ORIGINATION FORM

Proposed Revisions to a Standard Plans Index
(Please provide all information – Incomplete forms will be returned)

Index Number: **17515**
Sheet Number (s): 1, 2, 6, 7, 8
Index Title: Standard Aluminum Lighting

CYLINDRICAL FOUNDATION DETAILS FOR MEDIAN BARRIER MOUNTED ALUMINUM LIGHT POLE

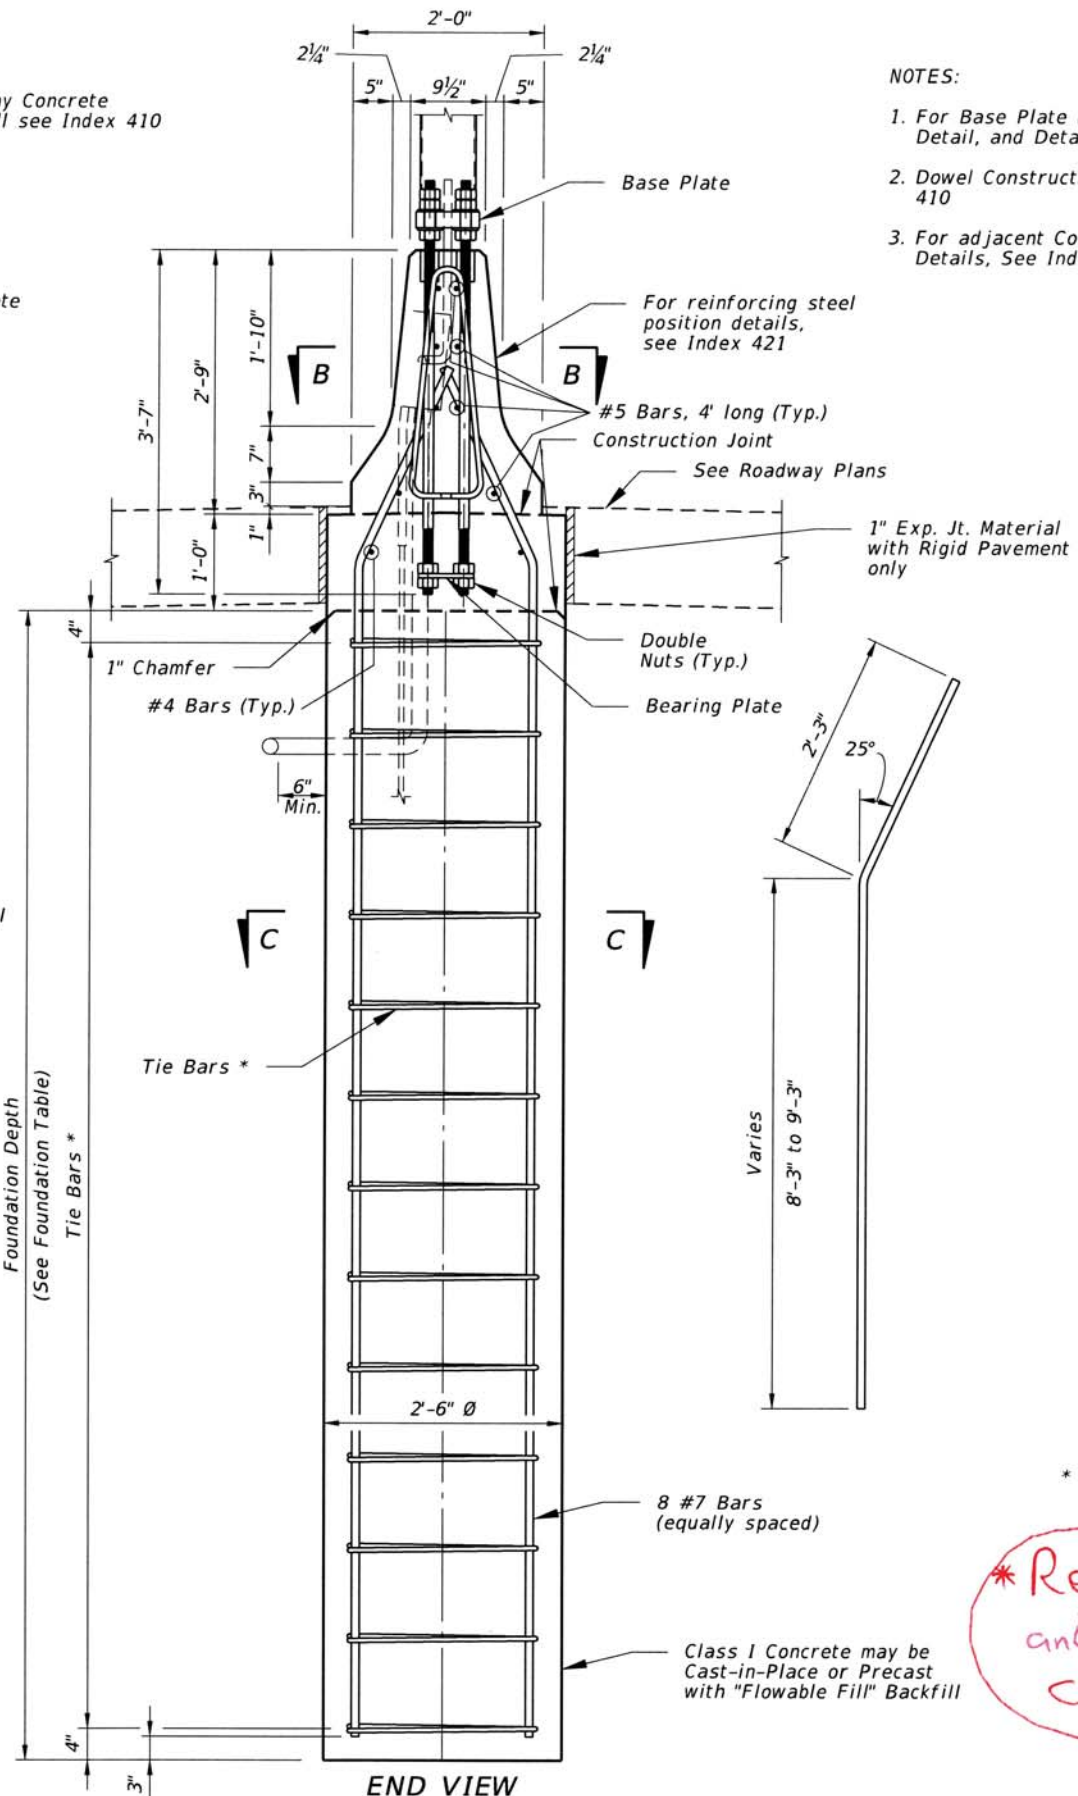
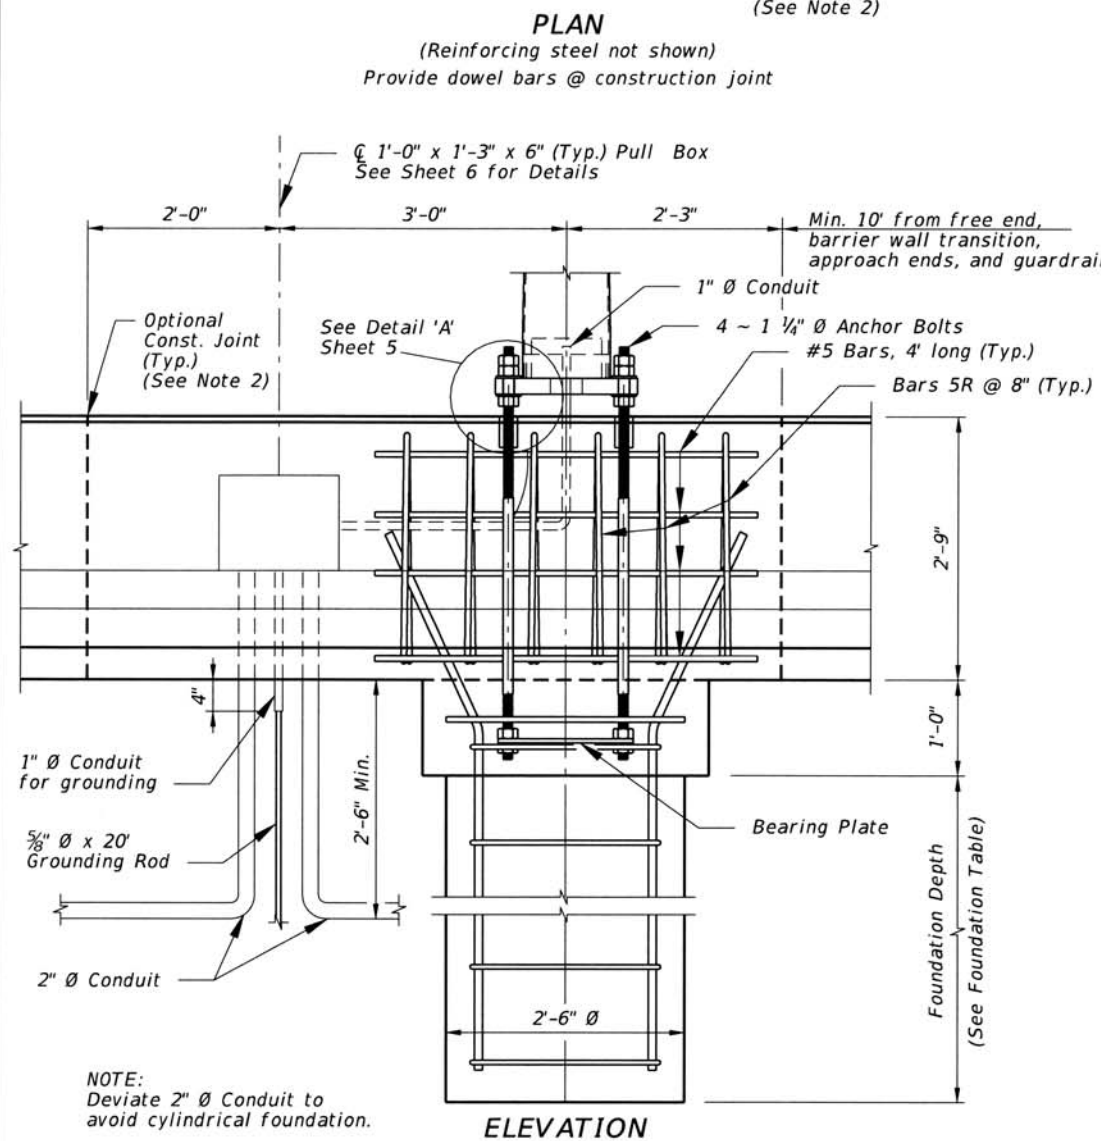
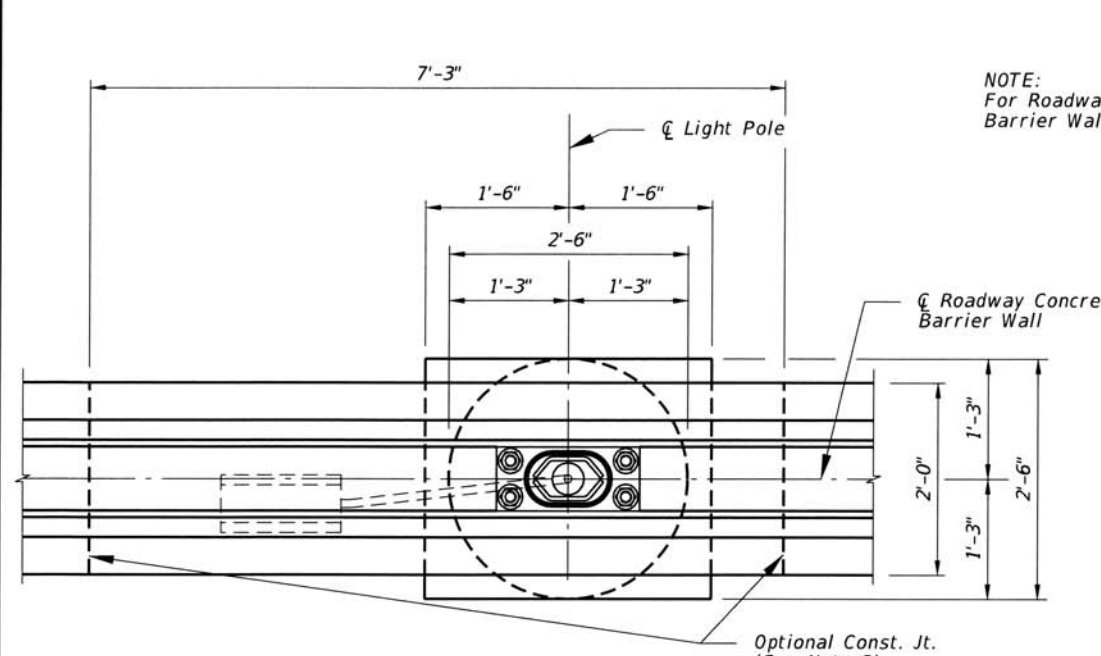
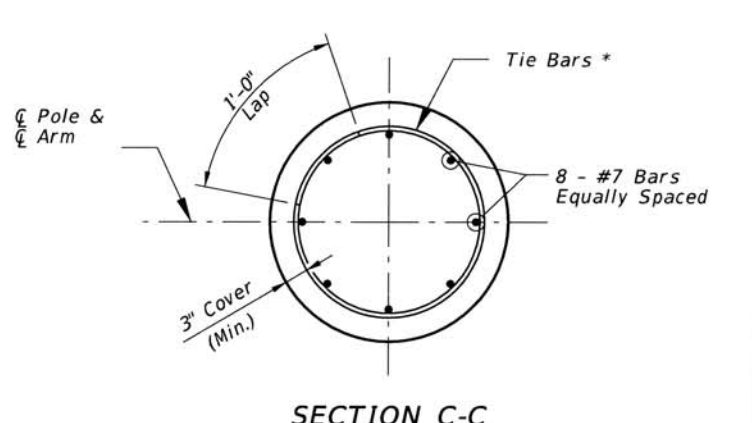
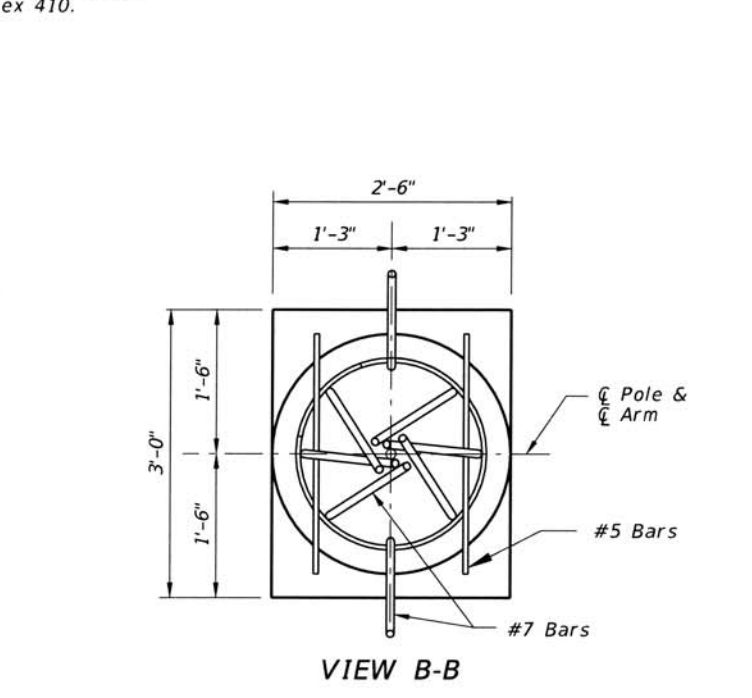
** Revised Plan, Elevation, End View, and Notes for Single-Slope Concrete Barriers...*

DETAILS FOR TRAFFIC RAILING (MEDIAN 32" F-SHAPE) MOUNTED ALUMINUM LIGHT POLE

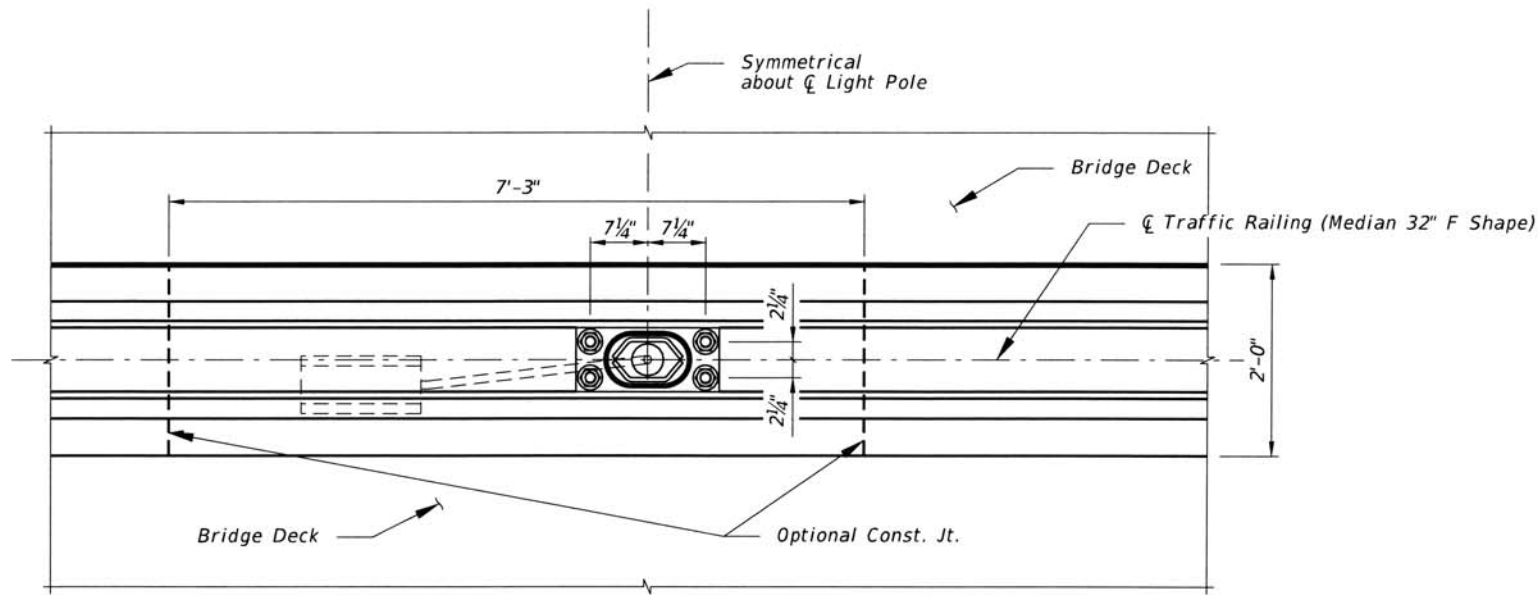
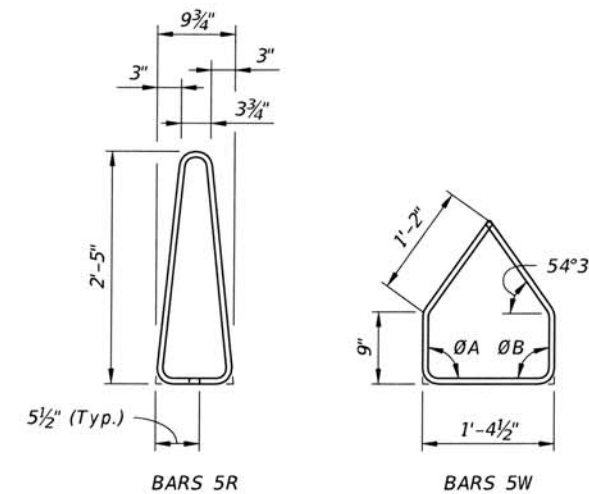
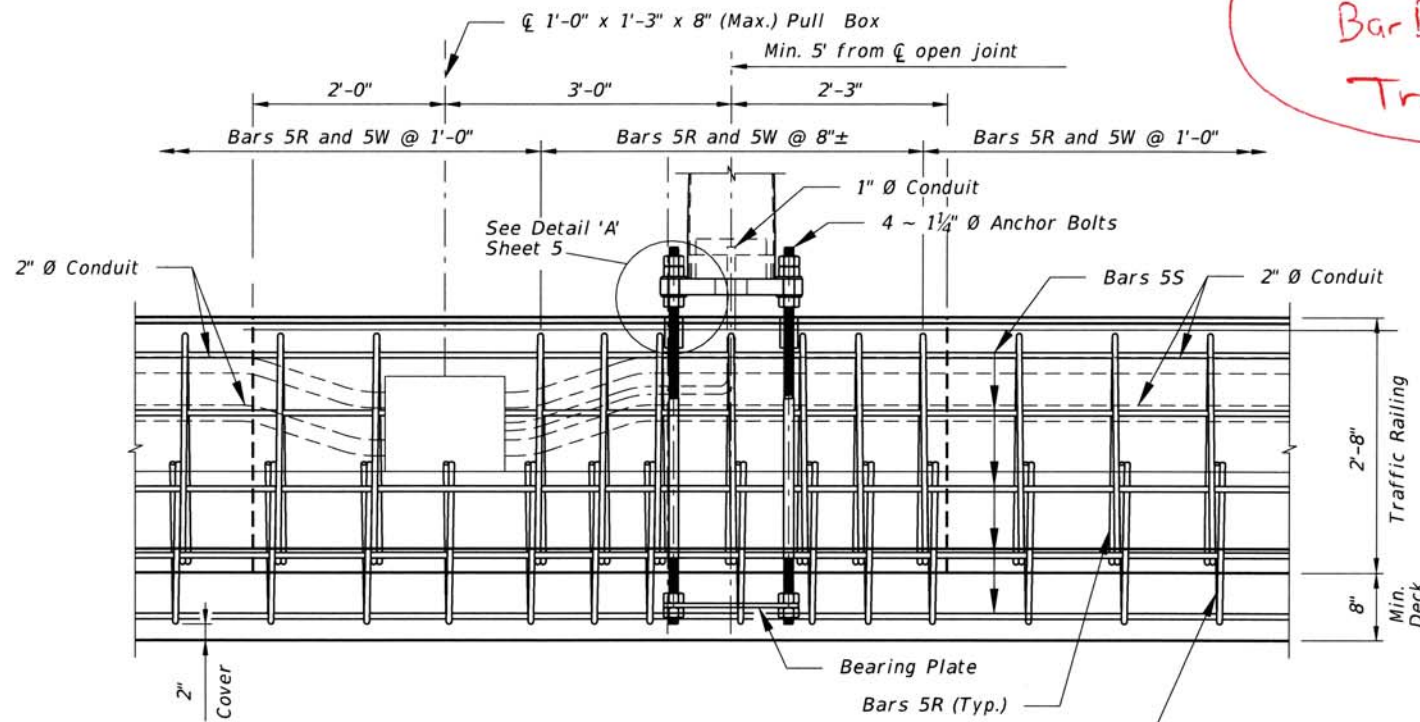
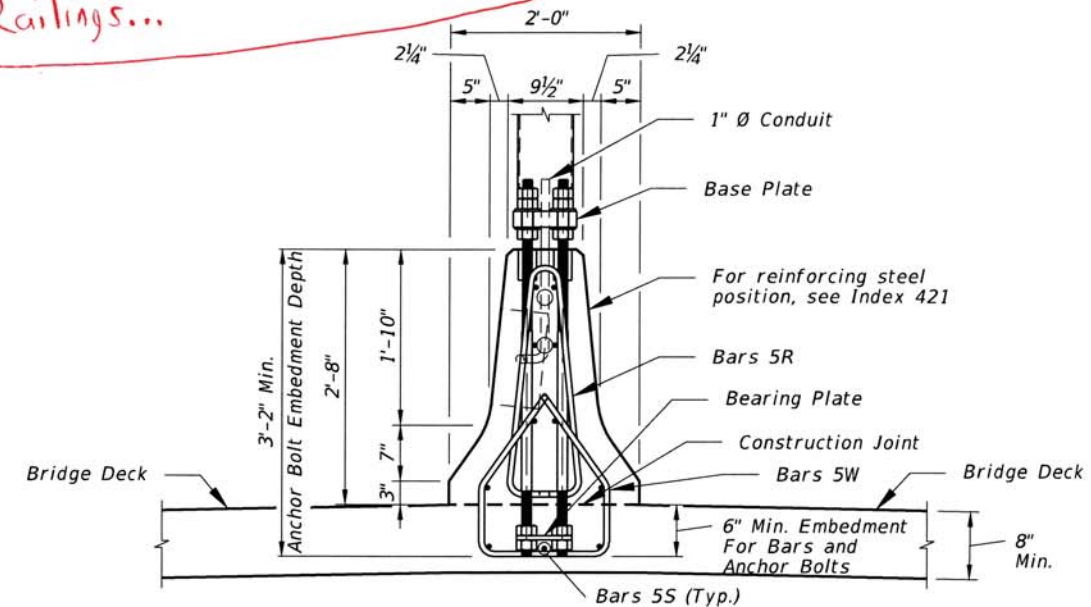
** Revised Plan, Elevation, End View, and Bar Bending Diagrams for Single-Slope Traffic Railings...*
